2217 Kingston Road - Application for Fence Exemption

Date: June 11, 2026

From: Acting District Manager, Municipal Licensing and Standards, East District

Attachment 2: Applicant's submission - Artists renditioning

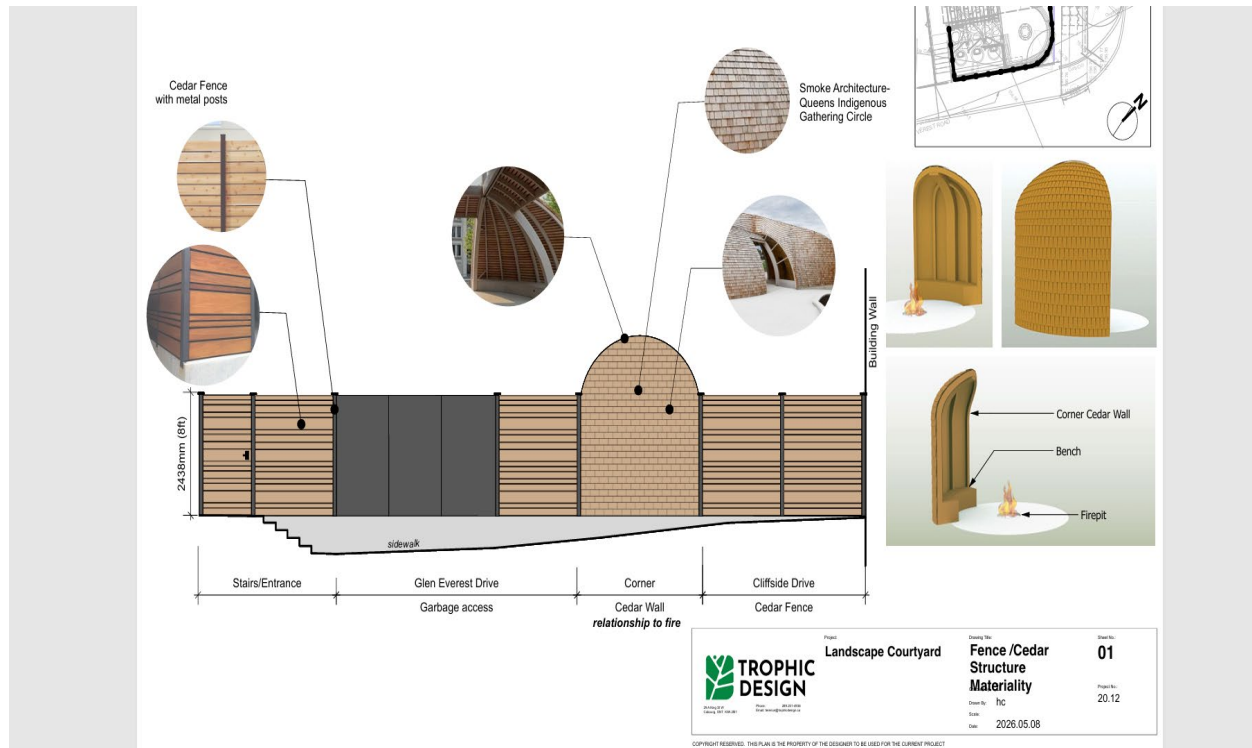
The proposed fence in the rear yard on the east side of the property will have a height of 3.26 meters. This is higher than the allowable 2.5 meters.

The proposed fence in the rear yard on the southeast side of the property will be within 2.4 meters of a driveway and not made of open construction.

GENERAL LOCATION	SPECIFIC LOCATION	CONSTRUCTION and DEFICIENCY	BY-LAW SECTION and REQUIREMENT*
Rear Yard	Rear yard – East Side	The proposed fence height is 3.26 meters, which is greater than the 2.5 meters allowed in the bylaw.	Chapter 447 Section 1.2 B(1) – Restrictions on Fences; Height Maximum allowable height is 2.5 meters.
Rear Yard	Rear yard – Southeast Side	The proposed fence in the rear yard on the southeast side of the property is within 2.4 meters of a driveway and not made of open construction.	Chapter 447 1.2C(1) – Restrictions on Fences; Open-Fence Construction Required. Any fence within 2.4 metres of any driveway shall be an open mesh chain-link fence or of an equivalent open-fence construction for at least 2.4 metres from the lot line at which the driveway begins so as not to obstruct the view of

Refuse to grant an exemption to Chapter 447, Fences, to the property owner of 2217 Kingston Road, for the proposed fence described in the Summary of this report.
